# CAMBRIDGE/LEXINGTON HOMEOWNER'S ASSOCIATION

This report notes background information, existing conditions, provides an analysis and makes recommendations concerning drainage patterns for two areas in the Lexington Addition. These two areas show conditions of poor drainage due to slow runoff and ponding of drainage water. In effect, these conditions have created tension among impacted neighbors and "finger pointing" as to who is responsible for the situation.

**RE: Backyard Drainage Runoff  
November 9, 1999**

FIGURE A

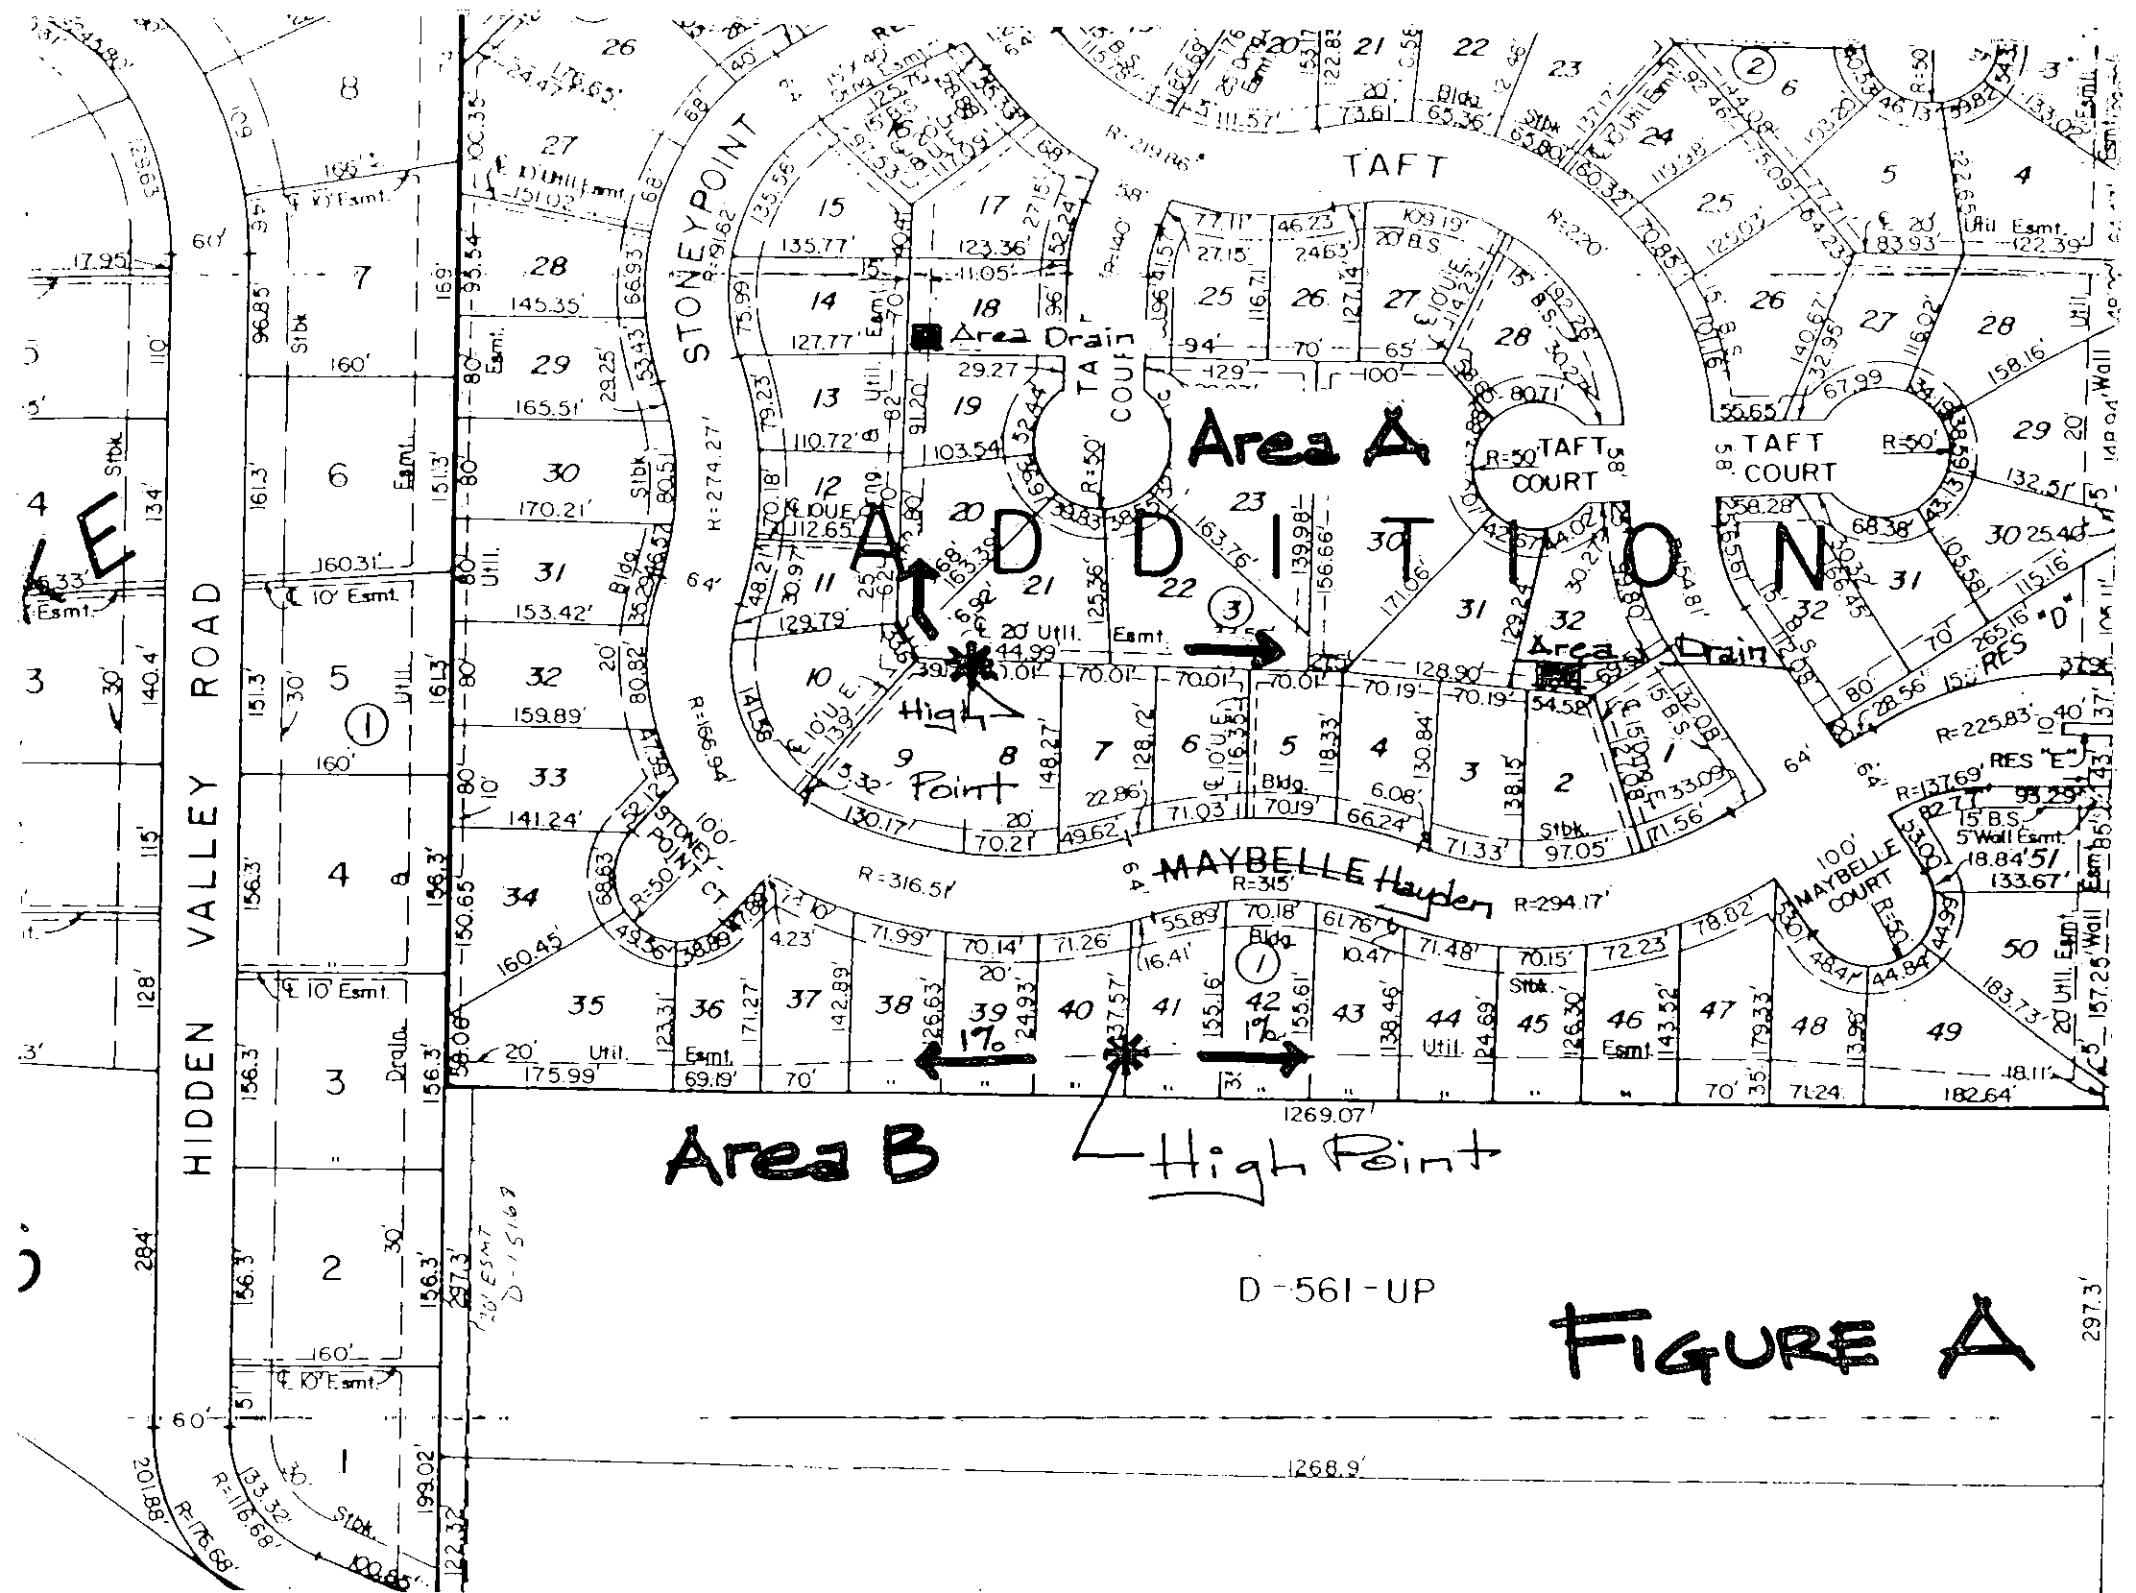
The plat and drainage plans for the Addition were prepared by Poe & Associates, Civil Engineers of Wichita. For Area A, the drainage plan exhibits a high point between lots 8 and 9. From the northwest corner of lot 8, drainage is designed to flow east at a 1% slope to an area drain at the rear of lot 32. Running northwesterly then north from the high point the drainage is designed to flow at a 1% slope to an area drain at the southwest corner of lot 18. For Area B, the drainage plan exhibits a high point between lots 40 and 41. Drainage flows east and west in a swale along the easement line north of the south property line. A 1% slope is designed for lots 36 thru 46 and lots 47 and 48 are slightly less at 0.85% and .84% respectively. At the time of original development, the drainage plan was designed to meet current City regulations. Recent revisions to the City's subdivision regulations require a 1% minimum slope for drainage runoff. Figure A shows the planned pattern of the drainage plan for these two areas.

FIGURE B

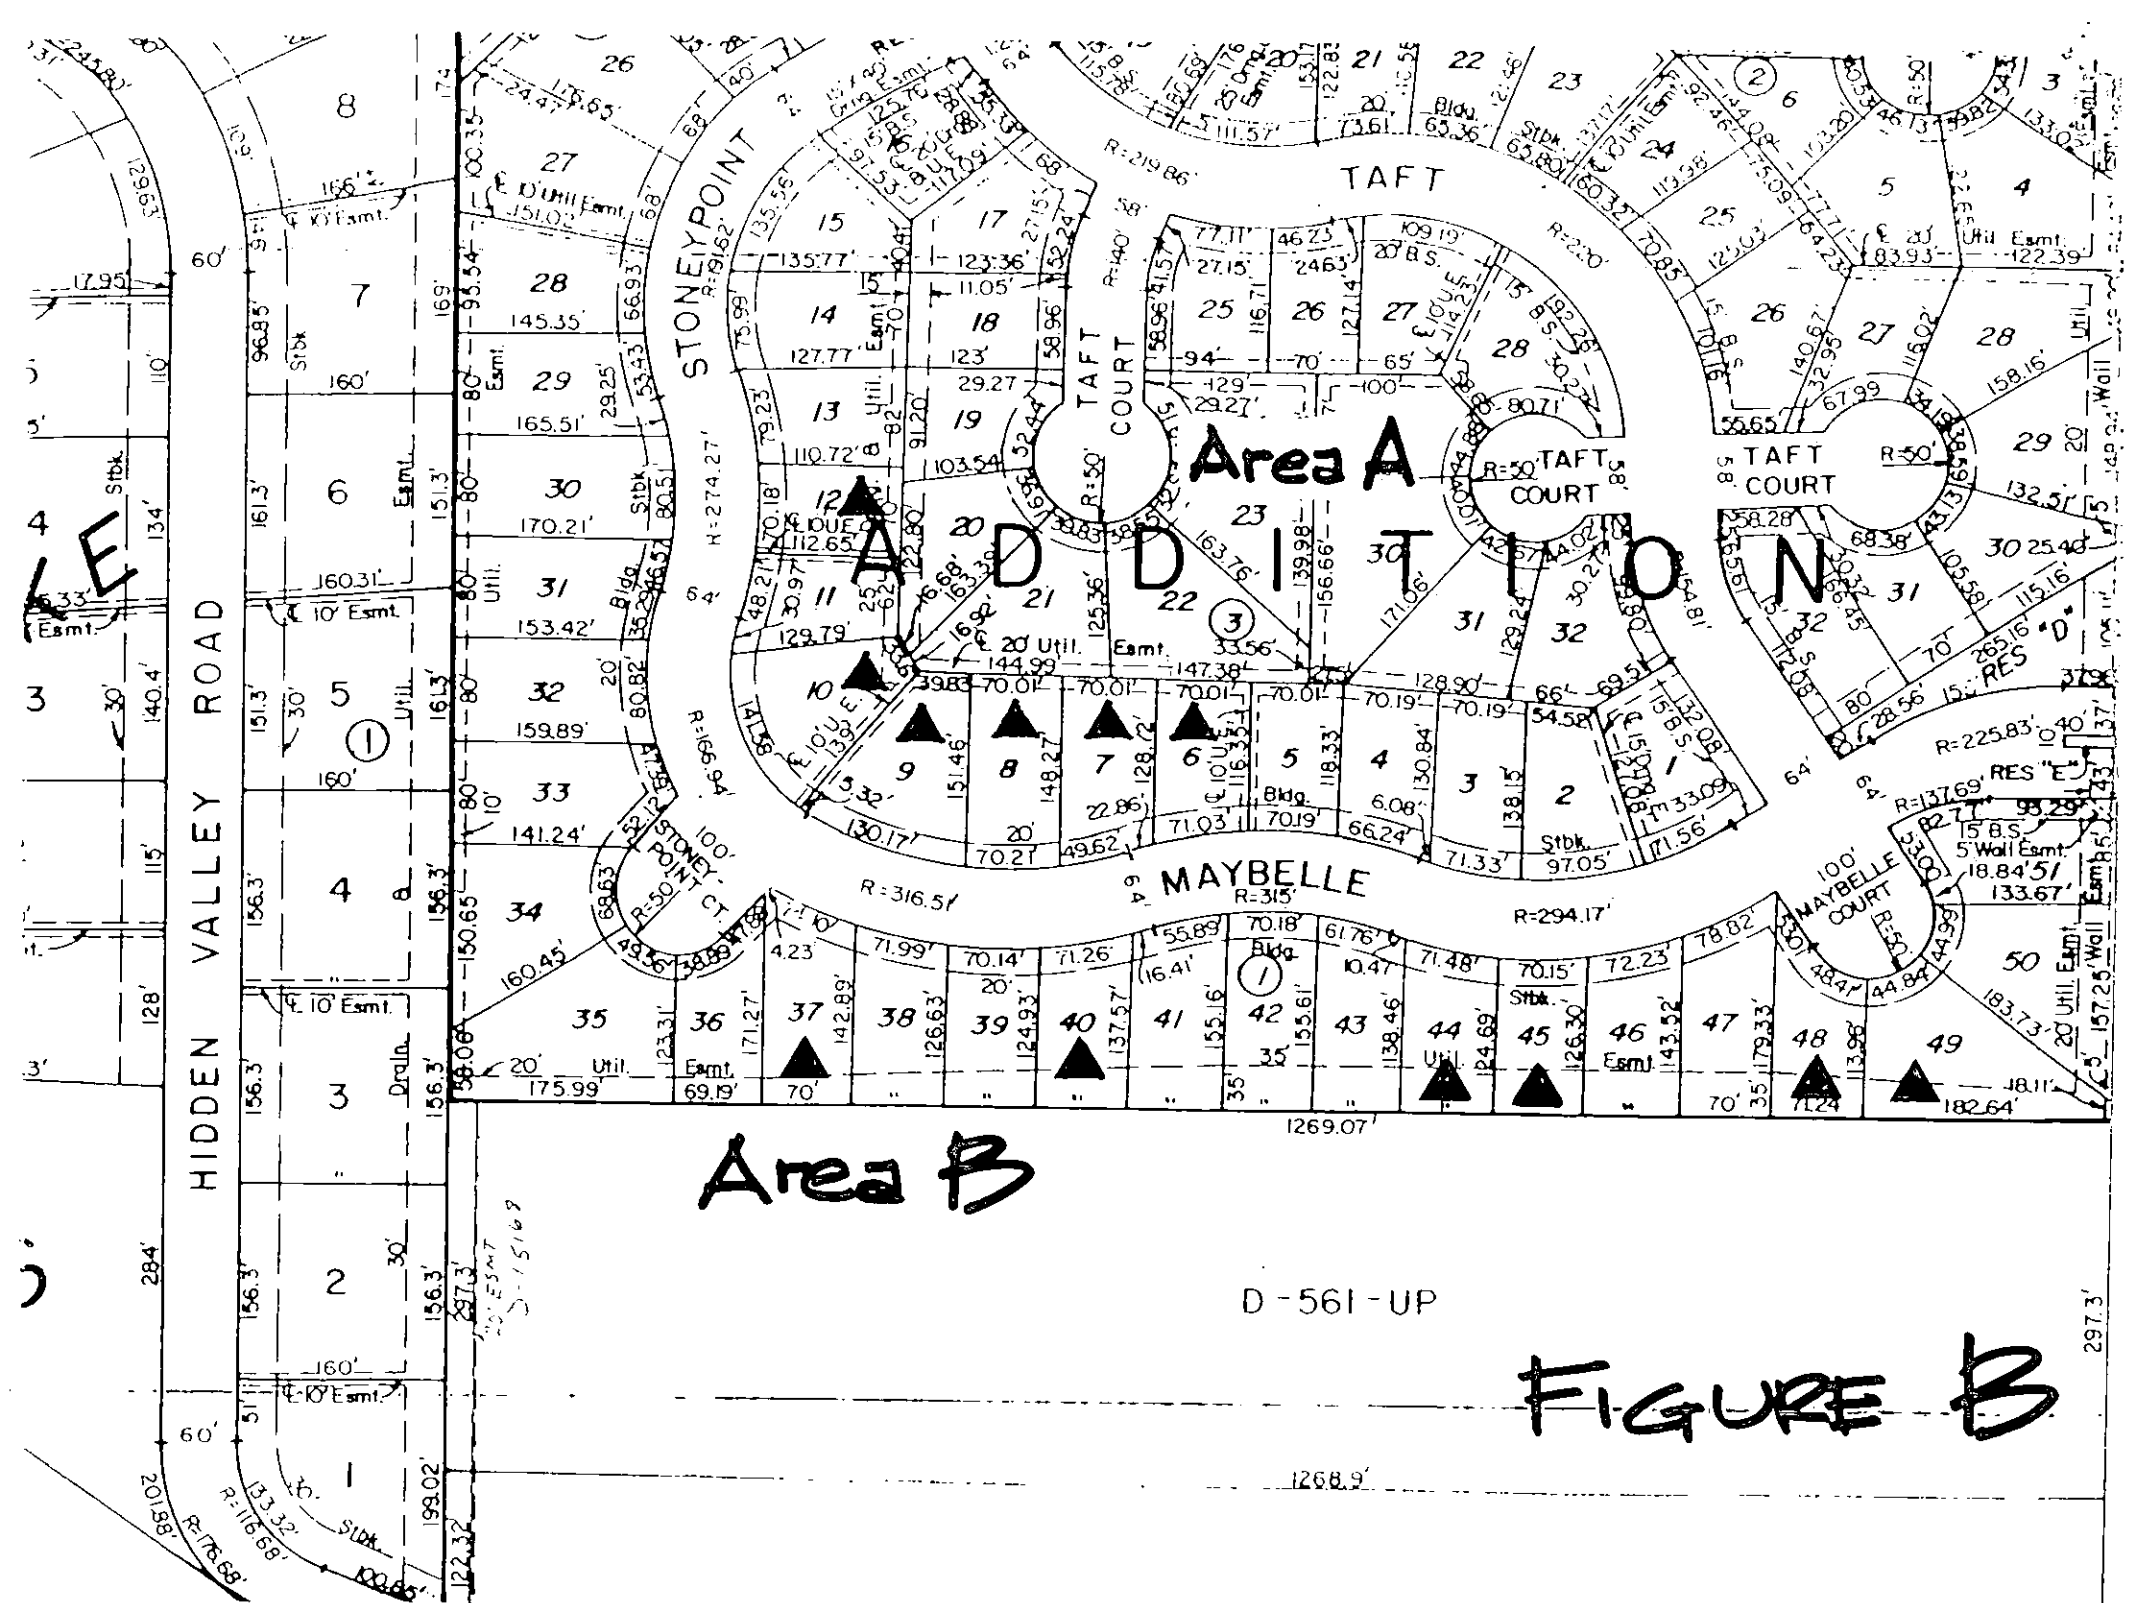
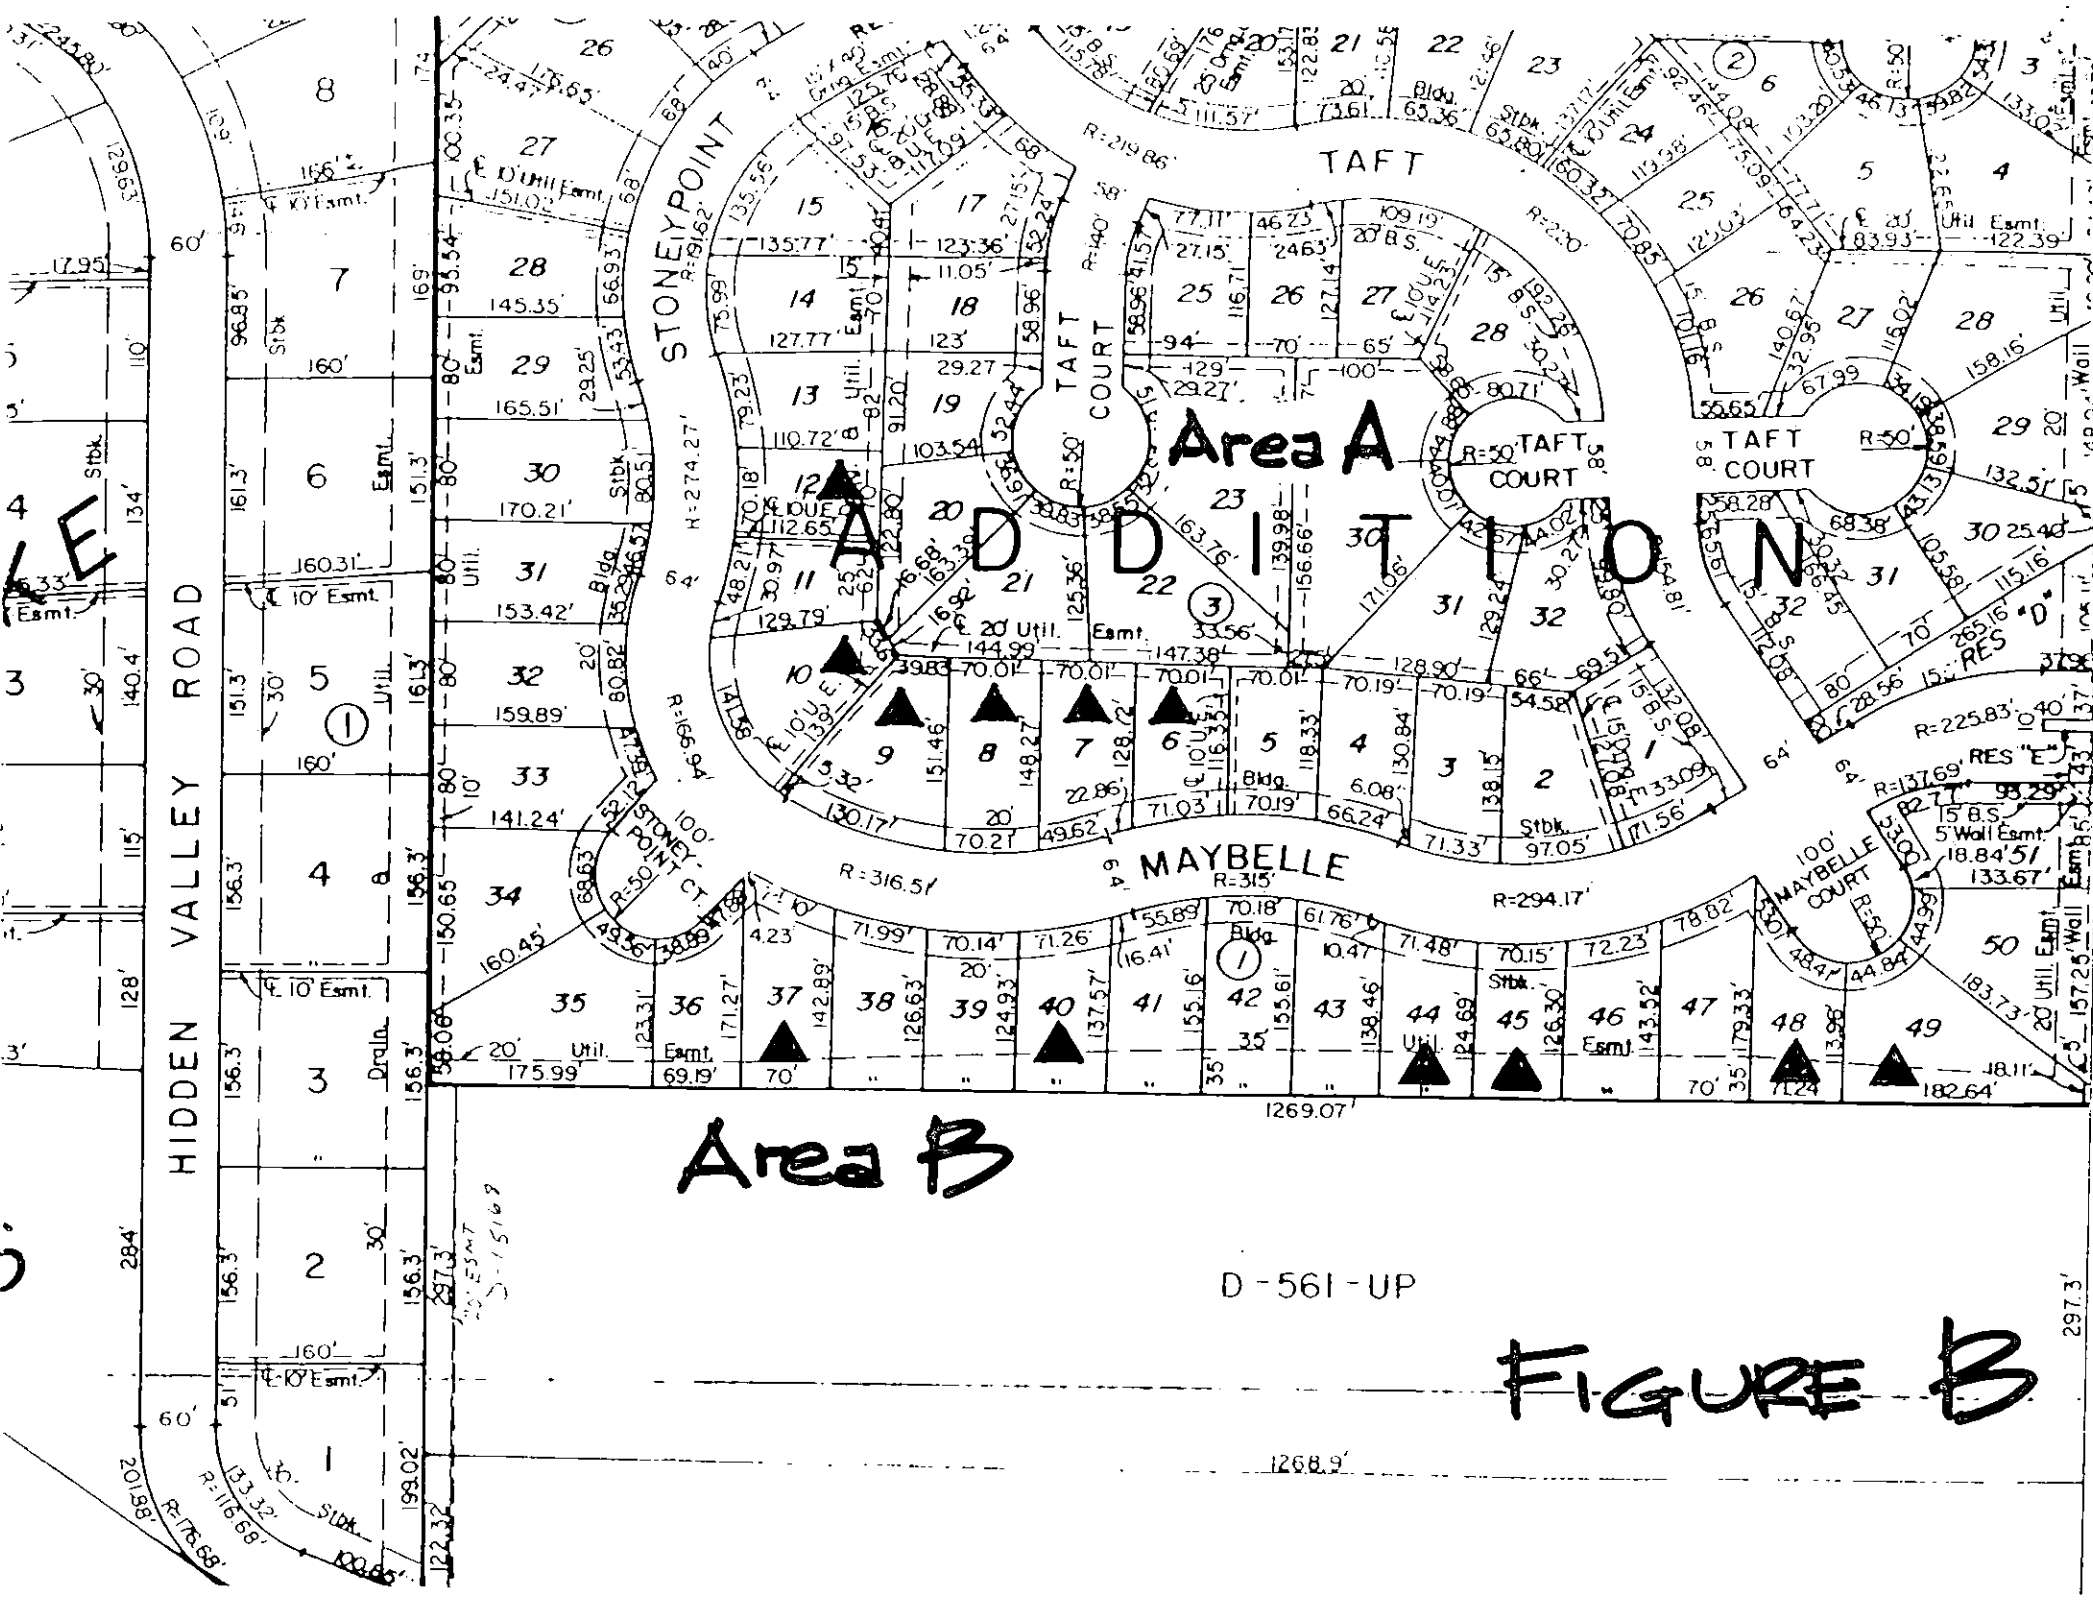
The varied slopes shown in the existing conditions indicates there are drainage problems. Most slopes less than 1.0 % and several flat areas will cause slow drainage and ponding. If the slopes are studied between existing conditions and the planned drainage it is possible to examine the problem more broadly. For area A, from the high point northward to the area drain on lot 18 there would be a 0.93 % if existing conditions in between were not considered. This is close to the planned drainage. Going east from the high point the drainage is only at 0.62% to the northeast corner of lot 5. Note that the grade shot there was taken at the general low point along the fence which would be the drainage flow once the soil is removed from the bottom of the fence. Further grade shots would need to be taken to relate to the area drain to the east.

For area B, from the high point west to the southwest corner of lot 37 the slope is 0.67%. If the slope is taken from the existing elevation at the southwest corner of lot 40 west to the same corner of lot 37 the slope increases to 1.05%. From the southwest corner of lot 44 to the southeast corner of lot 47 the slope is 1.02%. Further analysis such as this along with the sequence of grading work for lots could be done to understand why 1.0% grades were not achieved uniformly as planned. This would not be practical now because improvements exist which limit the possibility of going back and regrading the subdivision throughout all of these problem areas.

While it would be ideal to regrade the problem areas to conform to the drainage plan it is not practical due to the improvements along rear lot lines made by homeowners. These improvements include grass, irrigation systems, swimming pools, fences and ornamental landscaping. It is important to note that all of these improvements were made by homeowners following grading and drainage work established by the builder. Due to the improvements in place, it is recommended that a system of area drains and French drains be implemented to solve the drainage problems of all lots which stand water after rains or irrigation use and have slope gradients of less than 1%. Figure B exhibits these lots. This work will require minor regrading and repairs to irrigation systems, lawn areas and perhaps damaged utility lines. To avoid adverse impact to adjacent lots by dumping drainage water from effected lots, it is recommended that underground drain pipes be extended to the area drains in place. Slopes of 2% minimum are recommended for regrading to new area drains and French drains on lots.
